Recall 15V-110

Rear Turn Indicators

R nineT (K21)

Service Information No. SI 63 001 16

Figure: Motor vehicle with correct rear turn indicators

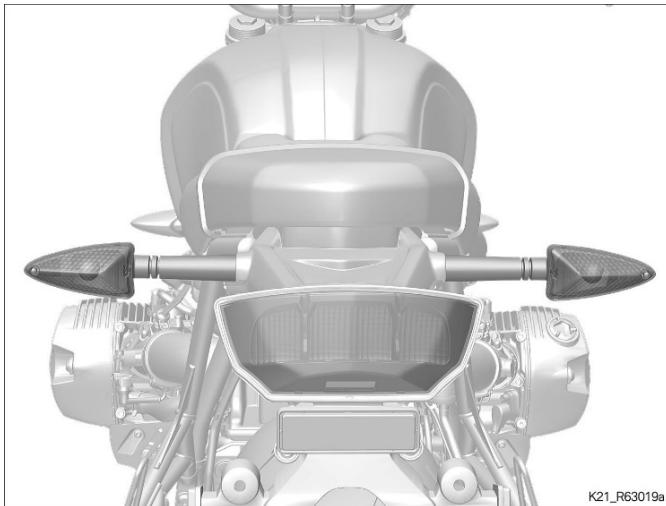
During the course of the quality analysis BMW Motorrad has determined that R nineT models produced between 11/2013 and 01/2015 have a slightly shorter set of rear turn indicators stalks than current production. As a result, in certain conditions, the rear turn indicators may be slightly obscured to a driver behind the bike.

All vehicles affected by this issue must have turn indicators that comply with statutory requirements installed.

The rear turn indicators are to be renewed according to work item 63 23 012 and 63 23 510.
